# Access Compliance Report

## Public Rights-of-Way

### (Curb Ramps)

Intersection ID: 30383	Main Street: BELLSOUTH_DR	Cross Street: CENTRAL_AV	Location: E
ADA ID: D74386E32FE2	Ramp Type: Perp	Initial Pass/Fail: Fail	Overall Compliance: No
Severity Score: 12.5			
Codes/Mitigation Info/Possible Solution		Field Measurements/Component Compliance

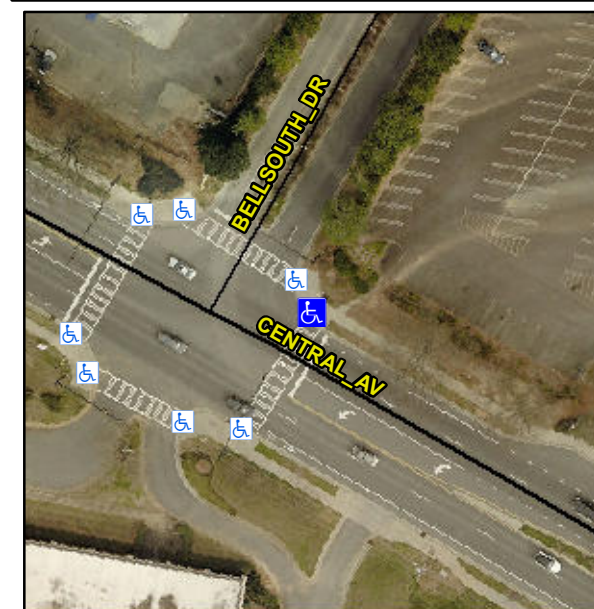
**Not Found, R304.2.2**

Compliance	Description	Data	Compliance	Description	Data
N/A	Ramp Length (in)	60.5	No	Ramp Slope (%)	8.5
Yes	Ramp Width (in)	48.0	Yes	Ramp XSlope (%)	1.0
N/A	Flare Type LT	N/A	N/A	Flare Type RT	N/A
N/A	Flare Slope LT (%)	N/A	N/A	Flare Slope RT (%)	N/A
N/A	Flare Traversable LT?	N/A	N/A	Flare Traversable RT?	N/A
N/A	Landing Length (in)	N/A	N/A	DWS Provided?	N/A
N/A	Landing Width (in)	N/A	N/A	DWS Contrast?	N/A
N/A	Landing Slope (%)	N/A	N/A	DWS Length (in)	N/A
N/A	Landing X Slope (%)	N/A	N/A	DWS Full Width?	N/A
N/A	Landing Curb? (Y/N)	N/A	N/A	DWS Offset (in)	N/A
N/A	Shared Landing?	N/A			
N/A	Gutter Ponding?	N/A	N/A	Gutter Slope (%)	N/A
N/A	Gutter Lip Ht (in)	N/A	N/A	Gutter X Slope (%)	N/A
N/A	Painted X Walk1?	Yes	N/A	Painted X Walk2?	N/A
	X Walk 1 Direction	To SW		X Walk 2 Direction	N/A
N/A	X Walk 1 Width (in)	111.0	N/A	X Walk 2 Width (in)	N/A
	X Walk 1 Slope (%)	3.1		X Walk 2 Slope (%)	N/A
	X Walk 1 X Slope (%)	2.6		X Walk 2 X Slope (%)	N/A

**Remove & Replace Entire Ramp.**
